Enclosure 1

Westinghouse has prepared AP600 Response to Requests for Additional Information as an enclosure to letter NSD-NRC-97-5216 of June 27, 1997. The majority of the responses appear to be acceptable. However, comments and clarifications apply to the following RAIs:

presented in Figure 3.10-1

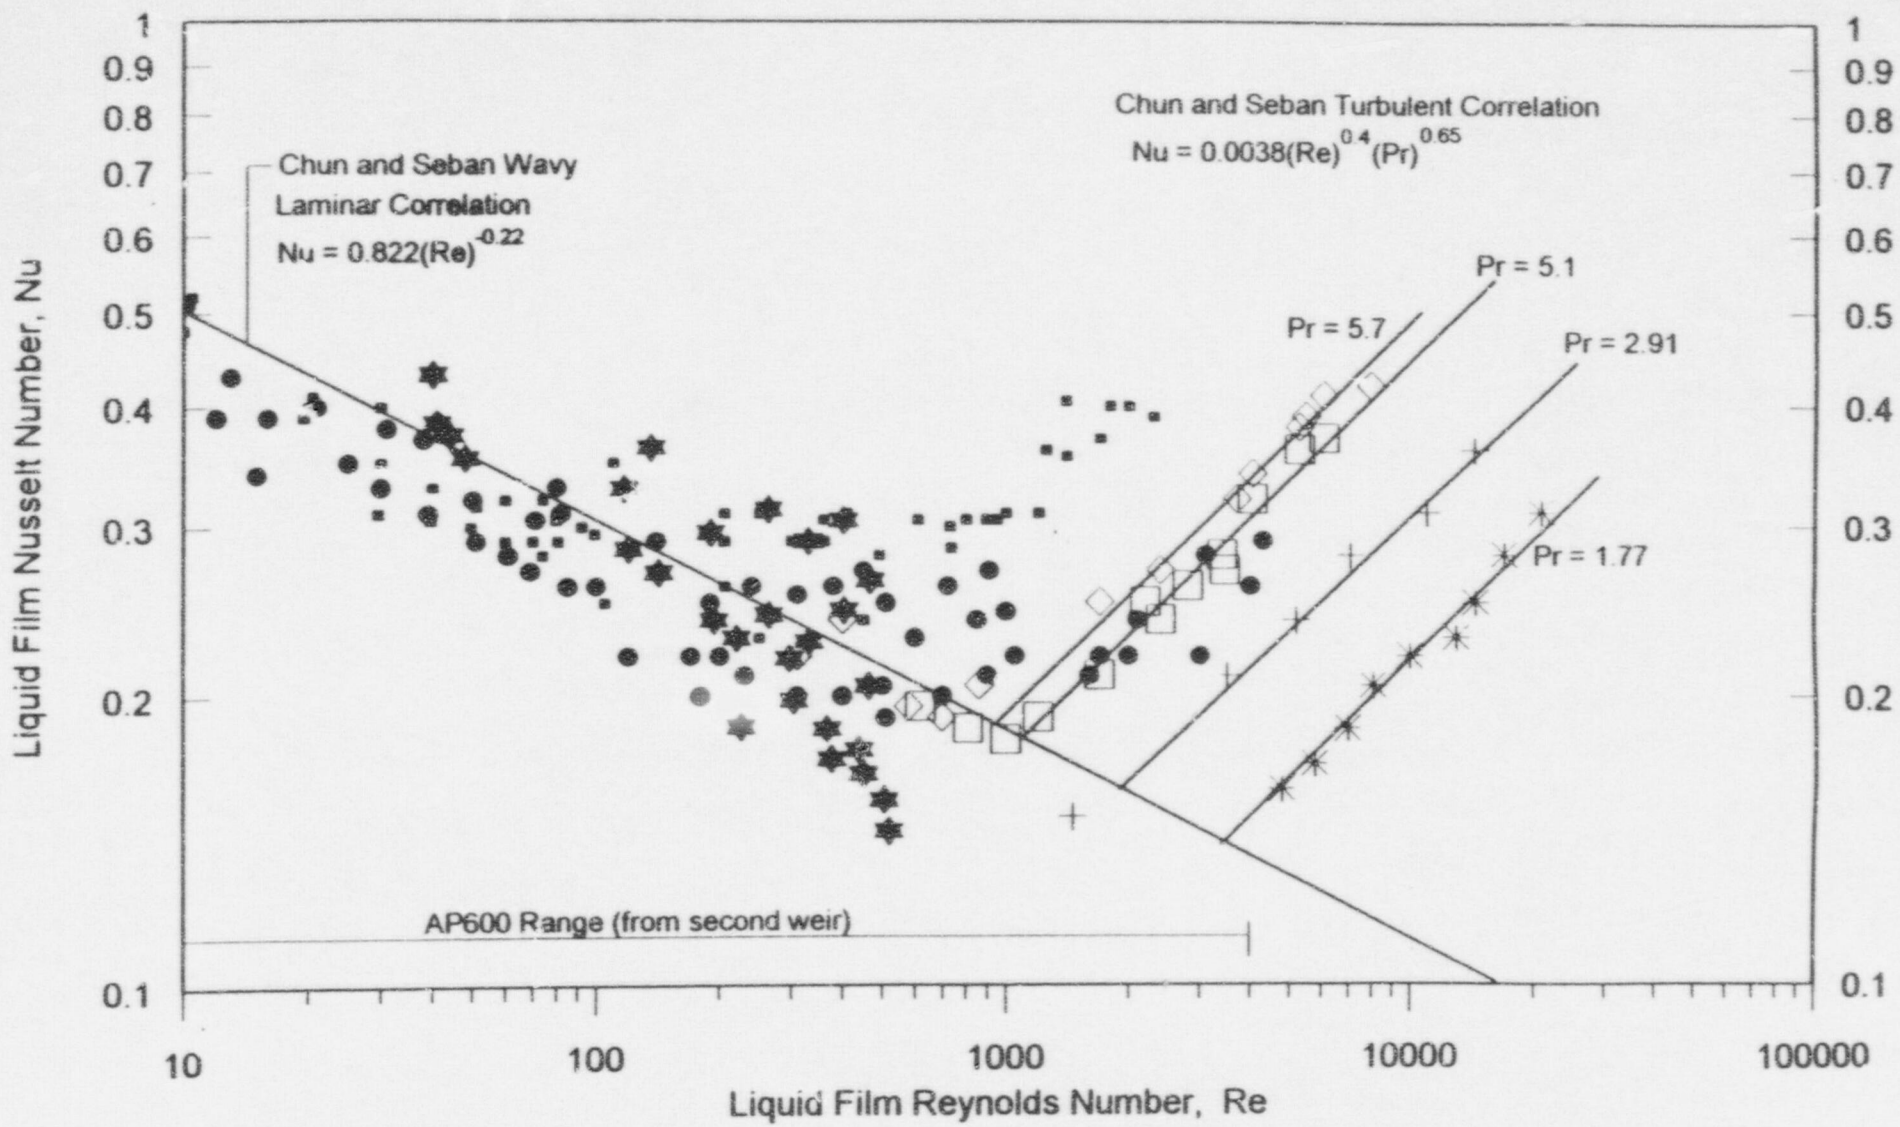
The condensation heat transfer data of Kutateladze et al. for working fluids of refrigerant 12 ($Pr = 3.5$) and refrigerant 21 ($Pr = 3.06$) is added to the graph given in Figure 3.10-1. This amended figure is attached. Also, the following text will be added to the text of section 3.10, "Chun and Seban Liquid Film Conductance Model," of WCAP-14326, Revision 1:

Insert 3: Kutateladze et al. determined the heat transfer coefficients for two working fluids in film condensation on vertical surfaces⁽²⁵⁾. These two sets of data are also plotted on Figure 3.10-1 and are nominally identified as having Prandtl numbers of 3.06 (actual range of 2.74 to 3.06) and 3.5 (actual range 3.14 to 3.52). At lower Reynolds numbers, $Re < 100$, the Chun and Seban correlation provides an upper bound to data for both working fluids. Between the range of $100 < Re < 400$, the Chun and Seban correlation provides a "best estimate" fit to the data. In the range of $400 < Re < 2000$, Nusselt numbers given by the Chun and Seban Wavy Laminar Correlation are lower than (conservative relative to) the data reported in Reference 25.
